NEW DENTIST OFFICE  
CHERIE DDS, LLC  
5145 NICHOLSON STREET  
MANVELLE, LA  
JOB No: 2025 DATE: 06-06-25  
DRAWN BY: BAW  
CHECKED BY: DCD

SHEET TITLE:  
BUILDING ELEVATIONS  
DRAWING NUMBER:  
**A102**  
SHEET No: 9 of 9

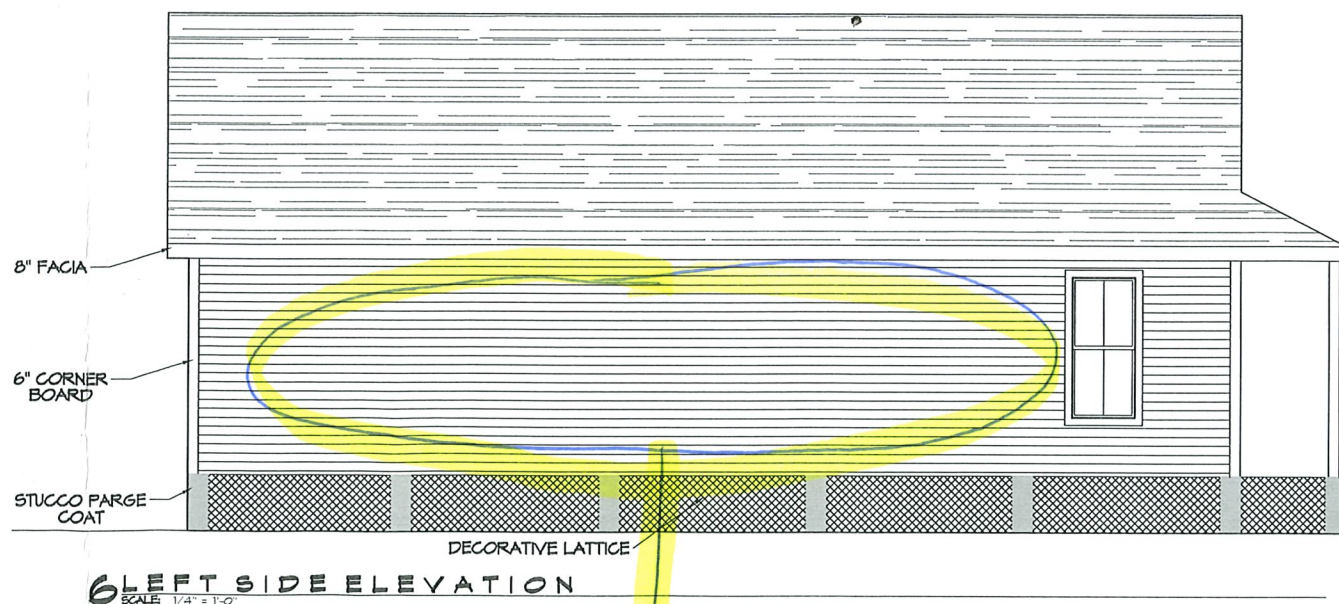
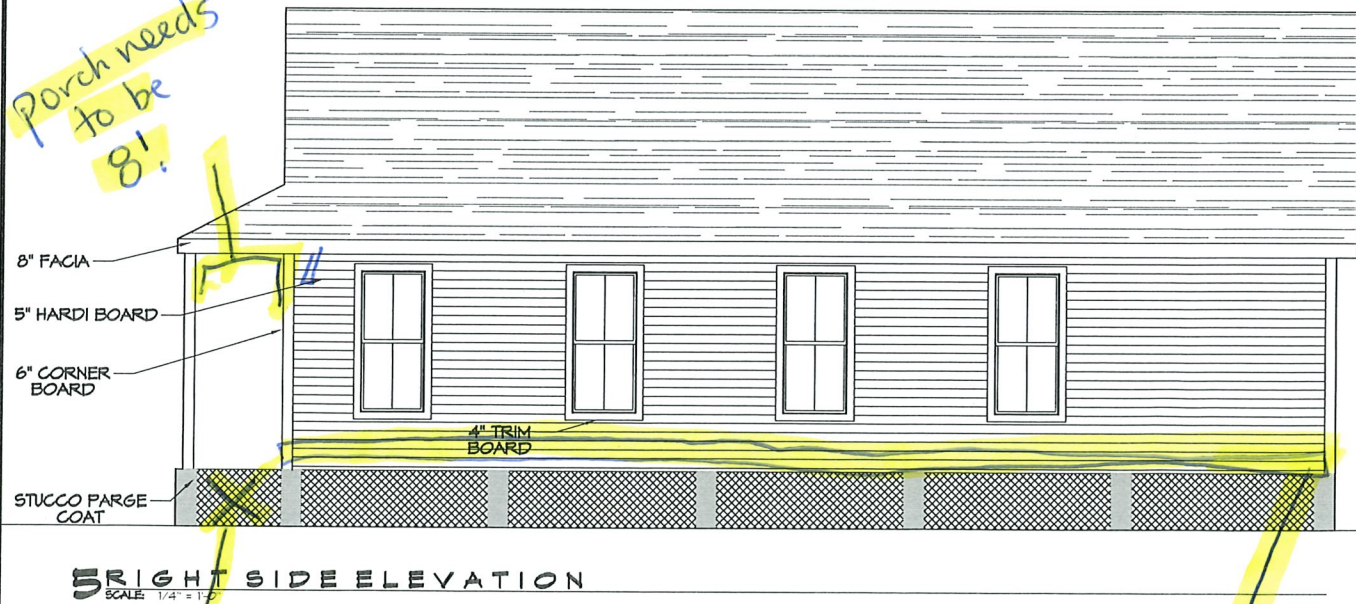
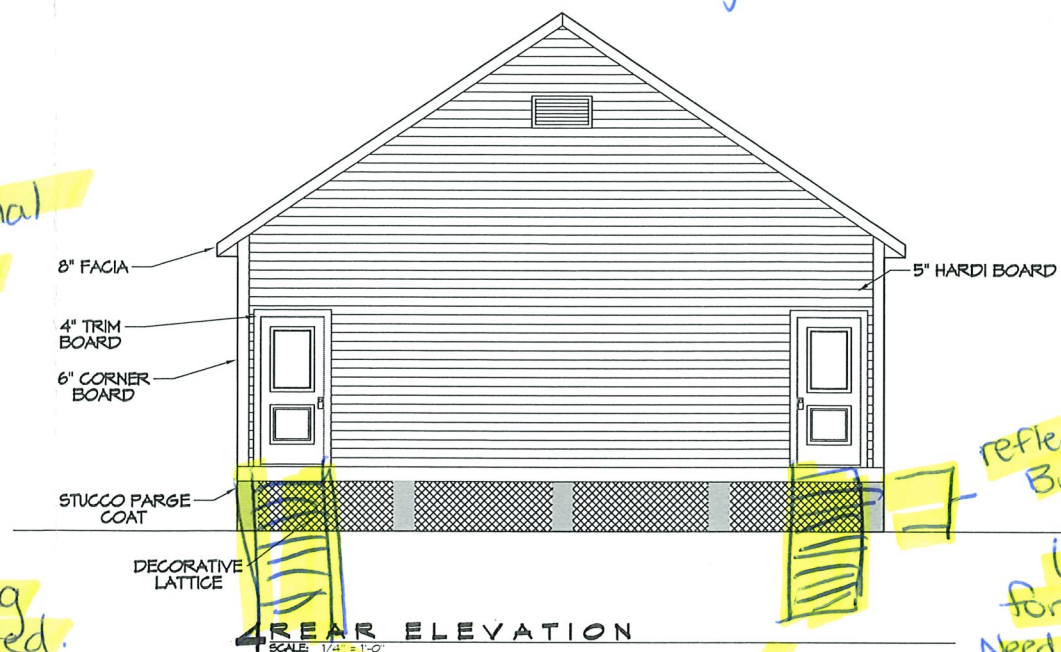
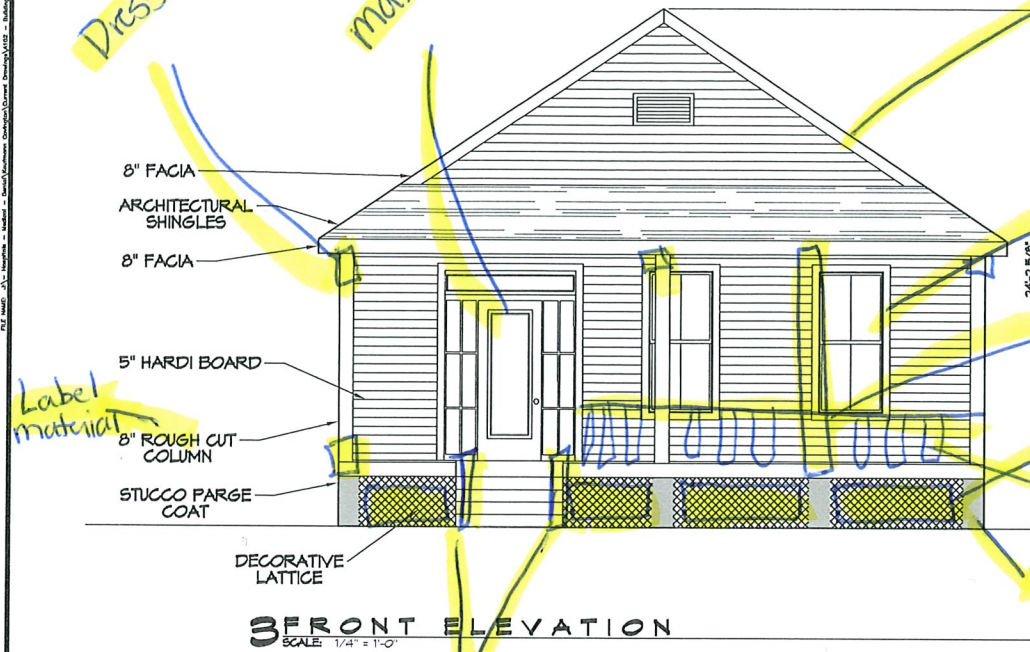
Dress up columns.  
material?

Needs to show  
shingles  
Roof Material?  
Size? specs?

\* No character defining features  
\* Need some more elements added  
to design.

Material?

Add additional  
column.

Picture frame  
screening.

Size of  
piers?

Railing  
needed.

Reflect Height of  
Building.

Left min  
for BFE + 2'.  
Needs to be at  
12' min.

Add stairs

Add railings  
(show typical detail for measurements)

Porch needs  
to be  
8'

No screening under  
porch.

Add Fascia  
Board.  
Building looks Floating

to open of a wall  
needs to be broken up.
